NORTHERN BEACHES LOCAL PLANNING PANEL MEETING

WEDNESDAY 2 SEPTEMBER 2020

ITEM 3.1	DA2020/0205 - 18 ALEXANDER STREET, COLLAROY - PART DEMOLITION WORKS AND CONSTRUCTION OF BOARDING HOUSE WITH ASSOCIATED CARPARKING AND LANDSCAPING
AUTHORISING MANAGER	STEVE FINDLAY
TRIM FILE REF	2020/499066
ATTACHMENTS	1 ↓ Assessment Report 2 ↓ Site Plan and Elevations

Application Number:	DA2020/0205
Responsible Officer:	Renee Ezzy
Land to be developed (Address):	Lot 9 DP 6984, 18 Alexander Street COLLAROY NSW 2097
Proposed Development:	Part Demolition works and construction of Boarding House with associated carparking and Landscaping
Zoning:	Warringah LEP2011 - Land zoned R2 Low Density Residential
Development Permissible:	Yes
Existing Use Rights:	No
Consent Authority:	Northern Beaches Council
Delegation Level:	NBLPP
Land and Environment Court Action:	Yes
Owner:	Simone Victoria Waights
Applicant:	Brendan Andrew Waights
Application Lodged:	03/03/2020
Integrated Development:	No
Designated Development:	No
State Reporting Category:	Residential - New multi unit
Notified:	14/03/2020 to 04/04/2020
Advertised:	14/03/2020
Submissions Received:	21
Clause 4.6 Variation:	Nil
Recommendation:	Refusal
Estimated C

Sheet Name ELEVATIONS

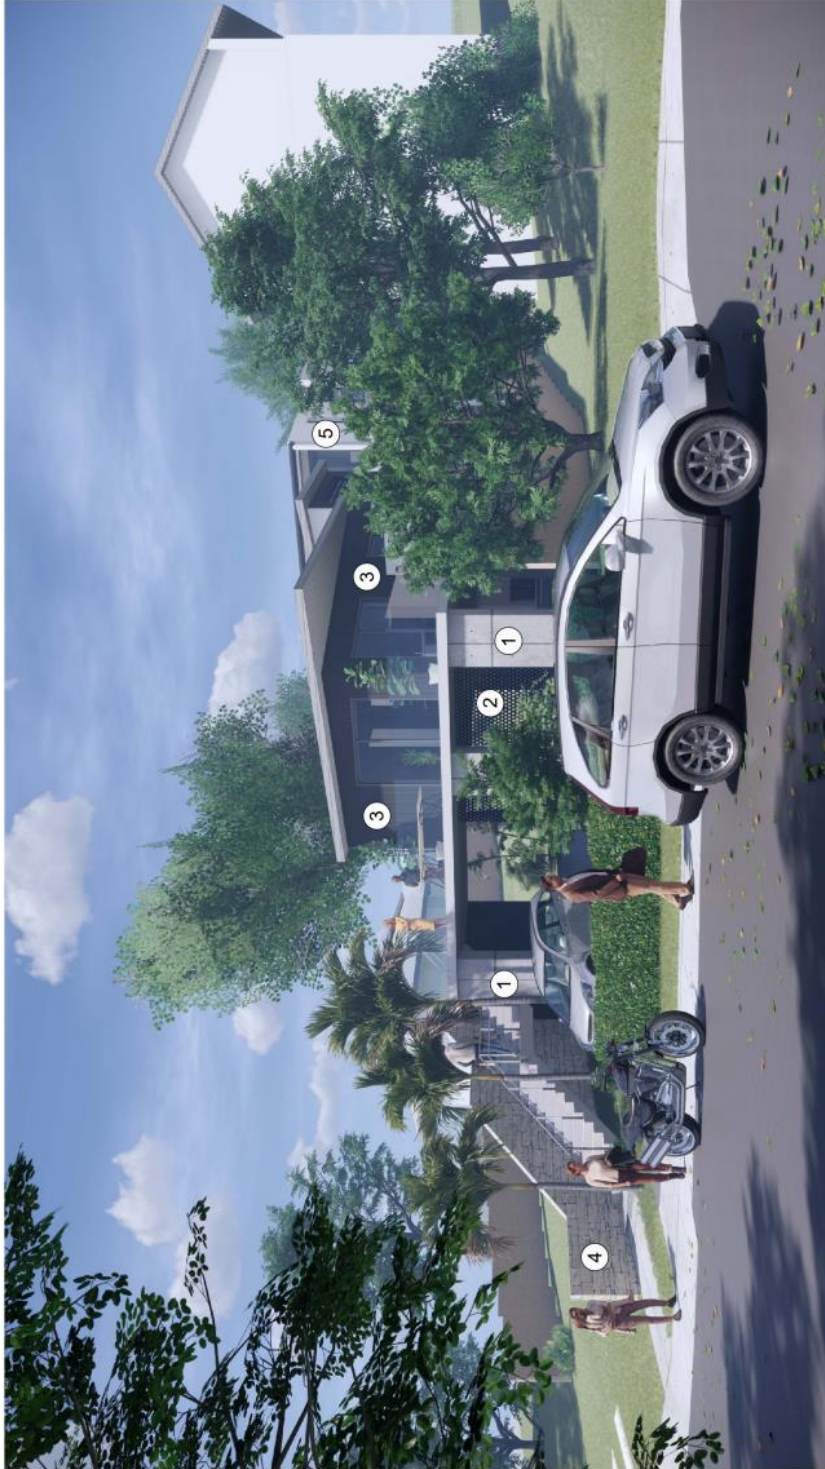
The proposed development does not provide compliant wall heights with the development seeking a wall height of up to 8.04m (12% variation).

The development incorporates a partially excavated basement structure below two levels of accommodation. While the design includes some stepping at the centre of the site, this response is not considered sufficient given the length of the building form.

The proposed development provides insufficient setbacks at all levels of the development. The excavated basement is between 0.25m and 0.9m from the boundary and the first and second floor levels provide 0.9m to the west and 1.2m to the east. The primary common open space area is located at the front of the site and will create real and perceived impacts on the visual and aural privacy of surrounding properties.

The development fails to meet the requirements of this control on most points. There are no progressively increased side and rear setbacks, the development includes large continuous wall planes which do not comply with the wall height control, the building footprint has not been minimised to address the slope of the land and there is a substantial lack of landscape planting on the site due to insufficient landscape area to support vegetation which could serve to soften the built form.
